Access Compliance Report Public Rights-of-Way (Curb Ramps)

Main Street: YELLOWSTONE_DR		Cross Street: CARLSBAD_DR		Location:	NE
ADA ID: RPAT211019104630	Ramp Type: Type 1 - Perpendicular Diagonal Initial Pass/Fail: Pass		Overall Compliance: No	Severity Score:	22

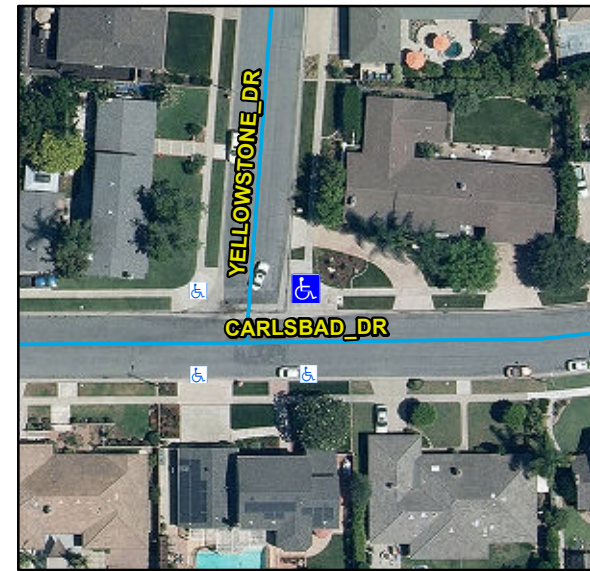
Compliance	Description	Data	Compliance	Description	Data
N/A	Ramp Length (in)	127	N/A	Flare Type LT	
Yes	Ramp Width (in)	58			Sloped
Yes	Ramp Run Slope (%)	6.2	N/A	Flare Slope LT (%)	4.9
Yes	Ramp Cross Slope (%)	0.9	N/A	Flare Traversable LT	No
N/A	Landing Present	No	N/A	Flare Type RT	
N/A	Landing Length (in)	N/A			Sloped
No	Landing Width (in)	N/A	N/A	Flare Slope RT (%)	5.1
No	Landing Run Slope (%)	N/A	N/A	Flare Traversable RT	No
No	Landing Cross Slope (%)	N/A	No	DWS Provided	No
N/A	Landing Movement Obstructed?	Yes	N/A	DWS Contrast	N/A
	Landing Movement Type	Curb	N/A	DWS Length (in)	N/A
N/A	Landing Shared	N/A	N/A	DWS Full Width	N/A
N/A	Clear Space	Yes	N/A	DWS Offset Left (in)	N/A
N/A	Clear Space To Crosswalk (in)	48	N/A	DWS Offset Right (in)	N/A
N/A	Marked Crosswalk 1	No	N/A	Marked Crosswalk 2	No
	Crossing 1 Direction	W		Crossing 2 Direction	S
	Marked Crosswalk 1 Width (in)	N/A		Marked Crosswalk 2 Width (in)	N/A

N/A	Ramp Inside Crosswalk 1	N/A	Yes	Ramp Inside Crosswalk 2	N/A
	Crossing 1 Slope (%)	0.1		Crossing 2 Slope (%)	3.5
	Crossing 1 Cross Slope (%)	1.4		Crossing 2 Cross Slope (%)	0.3
Yes	Gutter Ponding	No	Yes	Curb Slope	1.9
Yes	Gutter Lip Height (in)	0		Road Run Slope (%)	0.2
Yes	Gutter Run Slope (%)	1		Road Cross Slope (%)	0.9
Yes	Gutter Cross Slope (%)	0.7			
Yes	Overall Surface Condition: Acceptable		No	Perp Joint Present	No
	Cross Gutter Present?	Yes		Spandrel Present?	Yes
	Replace Cross Gutter?	No		Replace Spandrel?	No

Remove & Replace Curb Ramp With Two New Directional Ramps or Equivalent.
